DRAFT

**Specific Site Assessment for
Coal Combustion Waste
Impoundments at Duke Energy
Carolinas Lee Steam Station**

Williamston, South Carolina

LEE STEAM STATION - ASH BASIN
Primary Dike @ STA 6+00

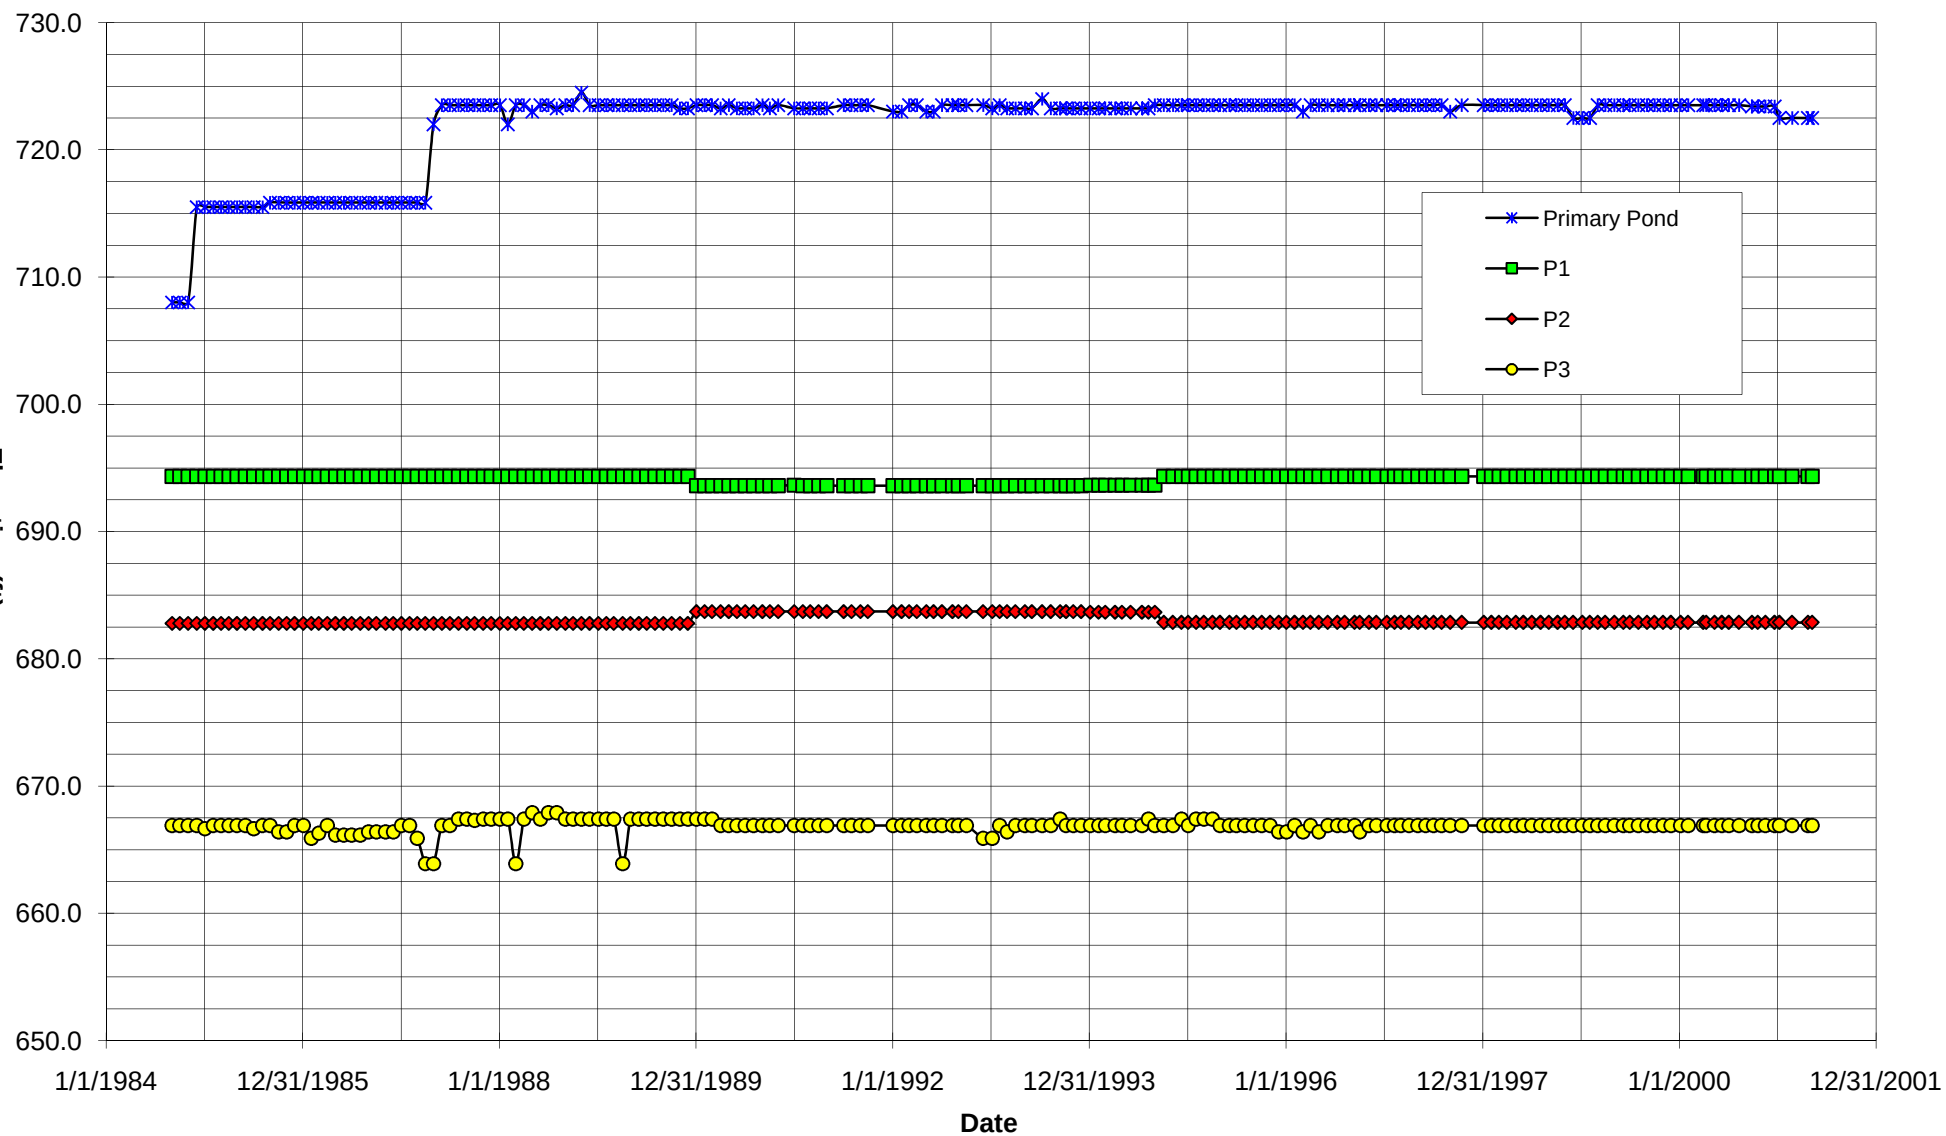
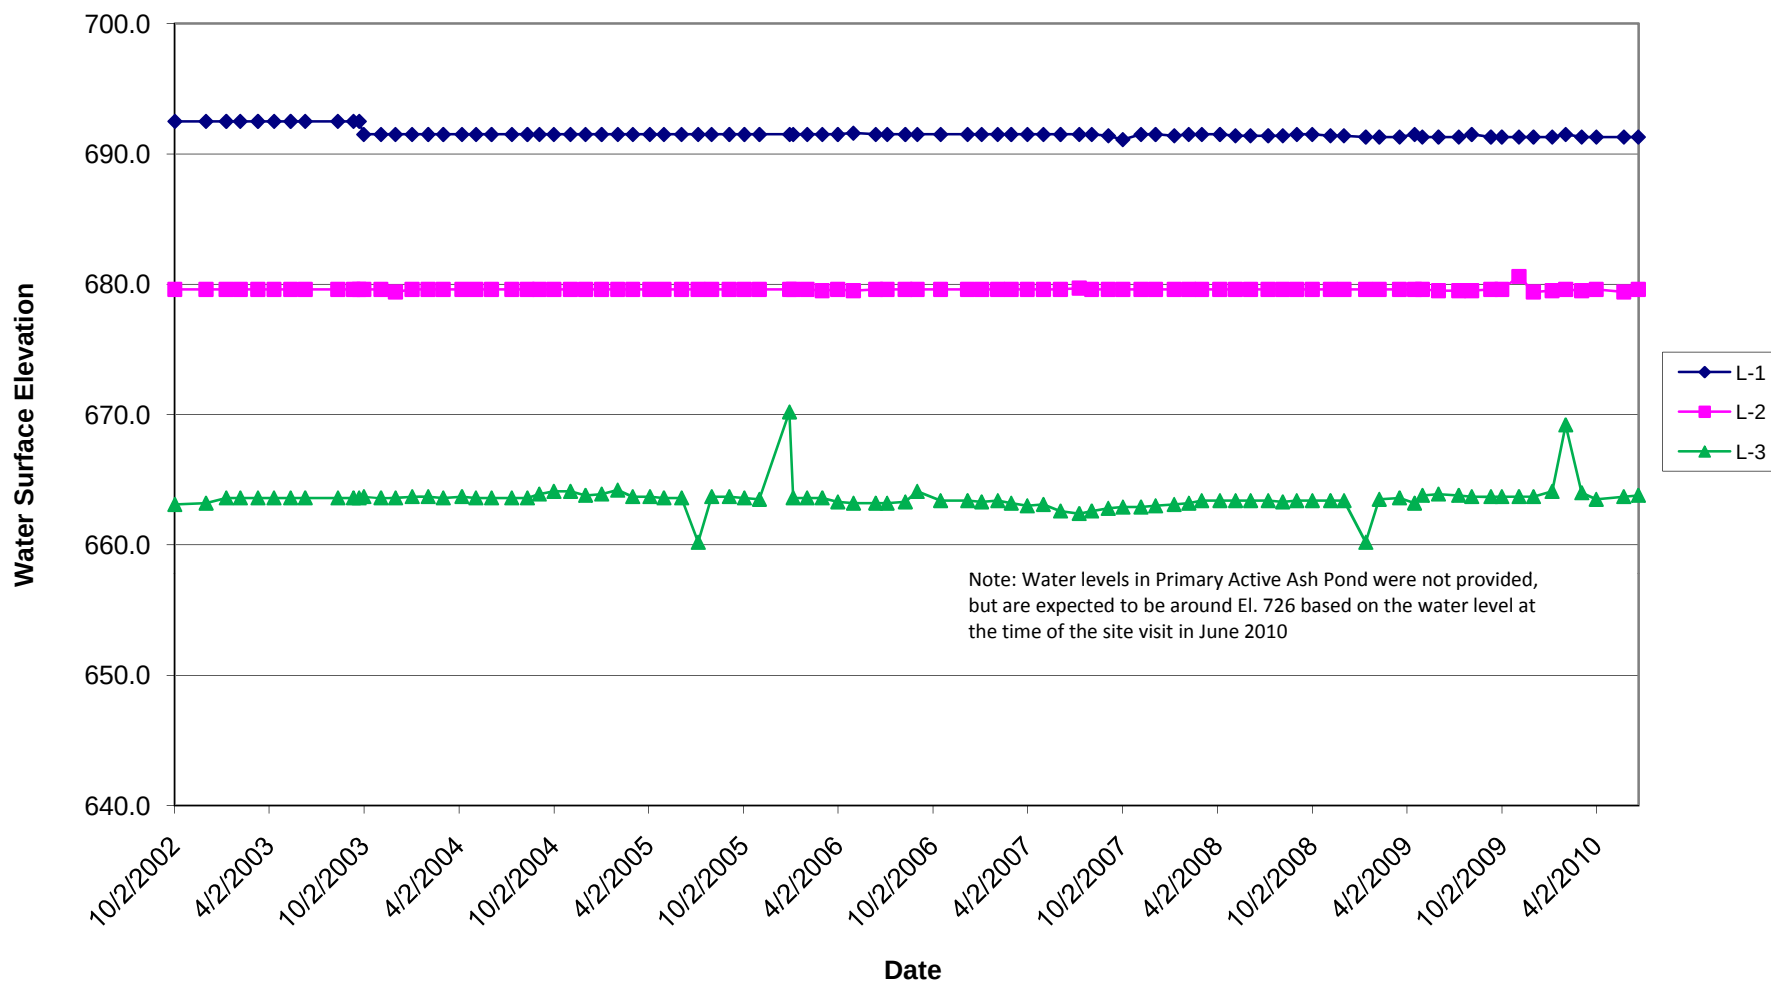
The water levels in piezometers L-1, L-2 and L-3, near the left abutment of the Primary Active Ash Pond dam, have remained relatively steady with time. The water level in piezometer L-3, at the dam toe, rose 6 to 7 feet in December 2005 and February 2010, but returned back to consistent levels in subsequent readings. The cause for these erratic readings is unknown.

The instrumentation installed at the Lee Steam Station CCW impoundments is functioning properly, and the frequency of readings is considered adequate. High water levels have been measured in Piezometers L-4 (between August 2009 and April 2010) and L-9 (compared with the other piezometers near the dam toe). The cause of these readings should be investigated.

LEE STEAM STATION - ASH BASIN Primary Dike @ STA 13+10

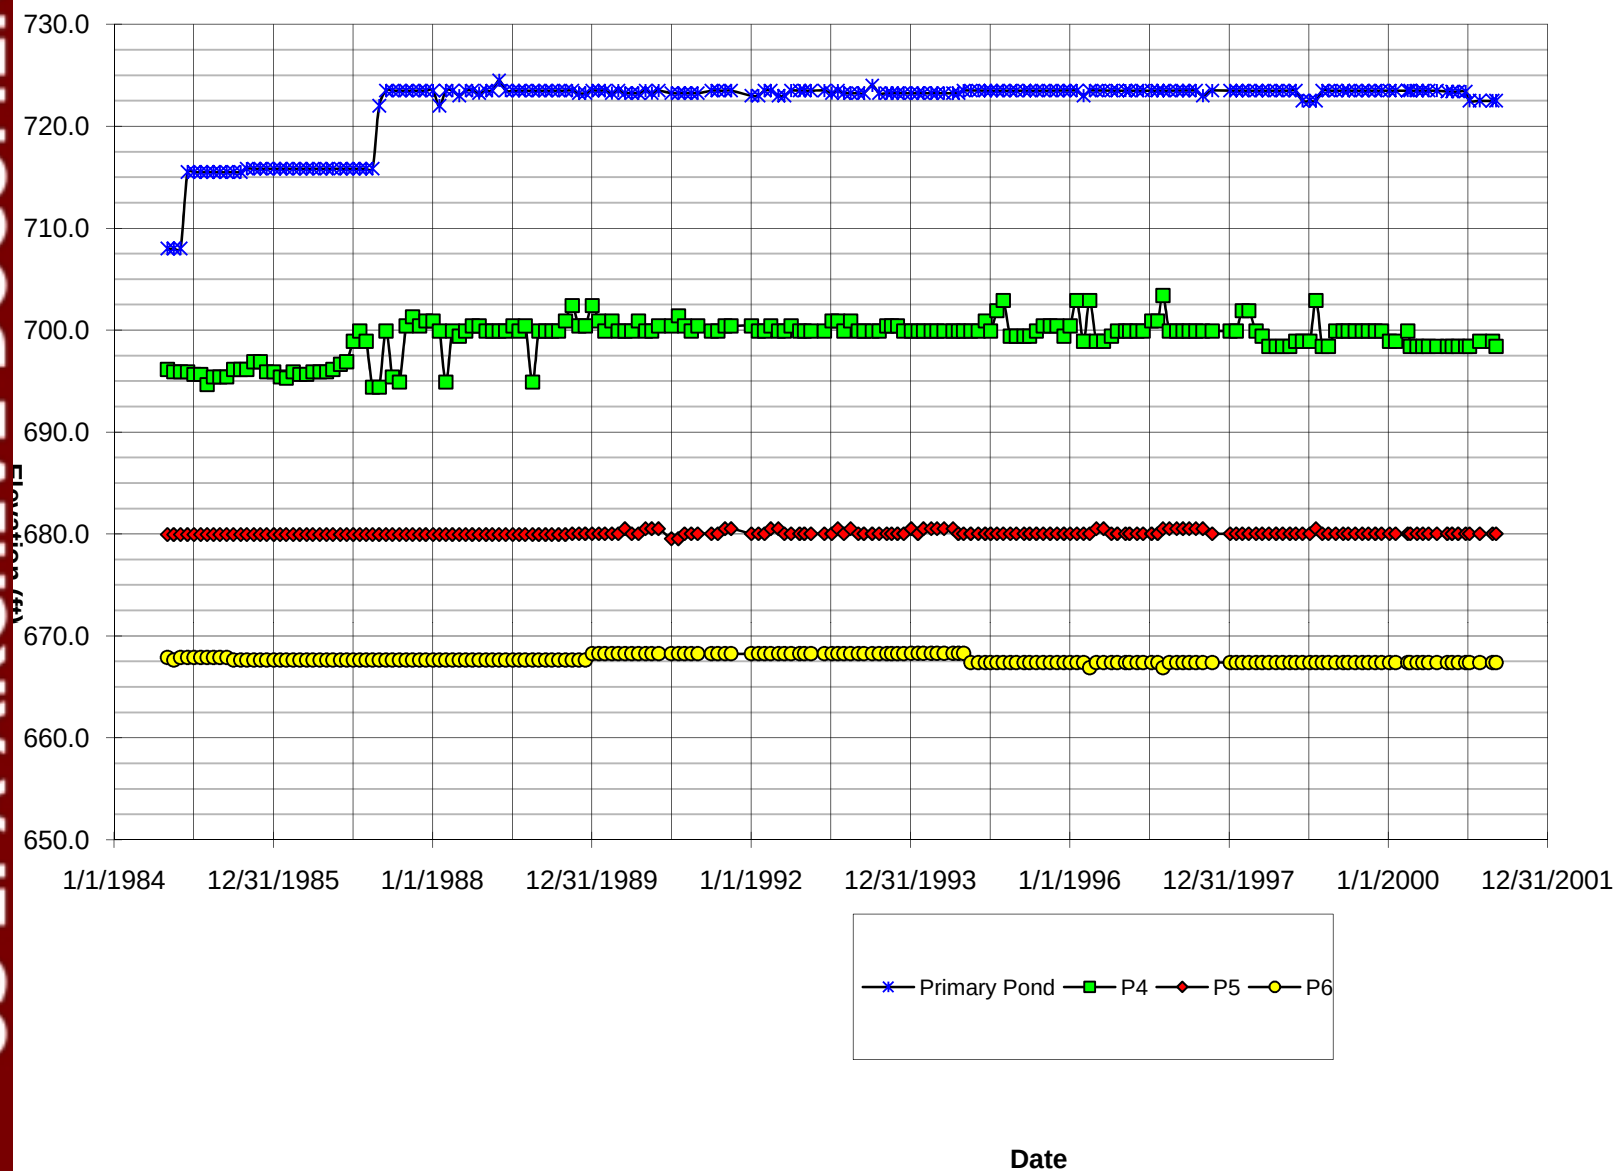
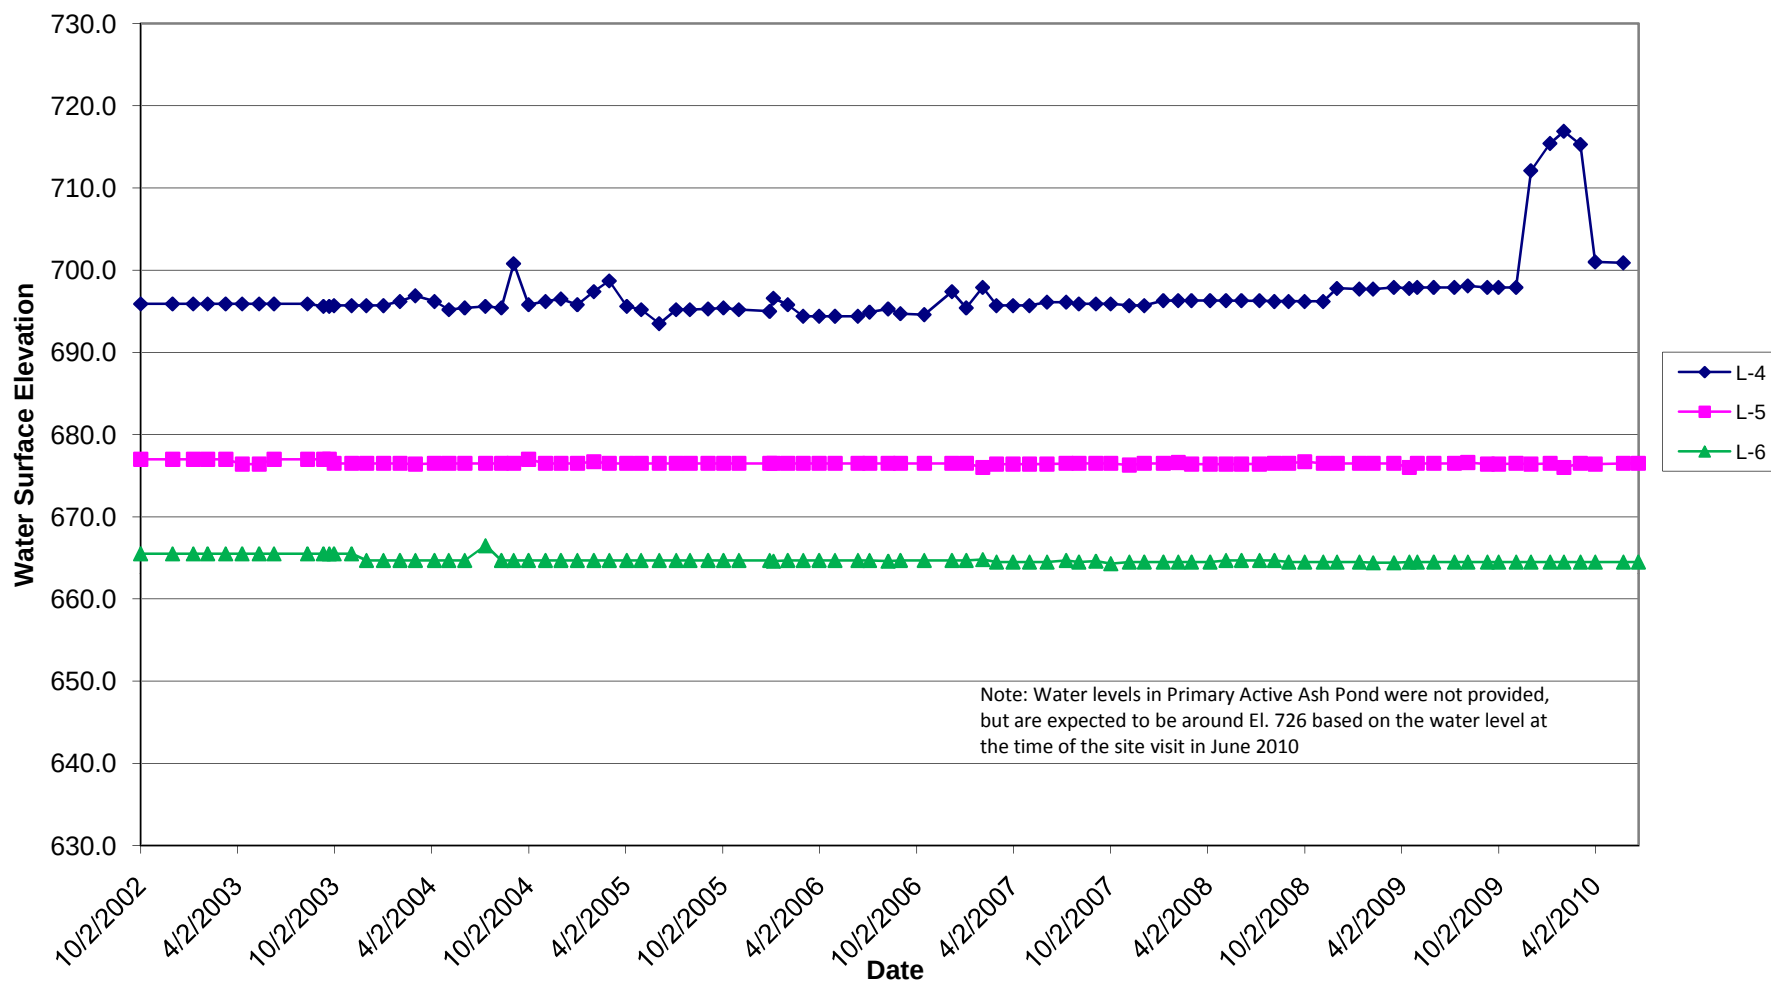
The water levels in piezometers L-5 and L-6, the lower two piezometers near the right abutment of the Primary Active Ash Pond dam, have remained relatively steady with time. The water level in piezometer L-4, near the dam crest, fluctuated regularly within several feet until around 2007. From 2007 until August 2009, the water level in L-4 rose steadily, and

between December 2009 and April 2010 it rose about 17 feet. In April 2010 the water fell back to within several feet of its previous levels. The cause for the sudden rise in water level in piezometer L-4 is unknown.
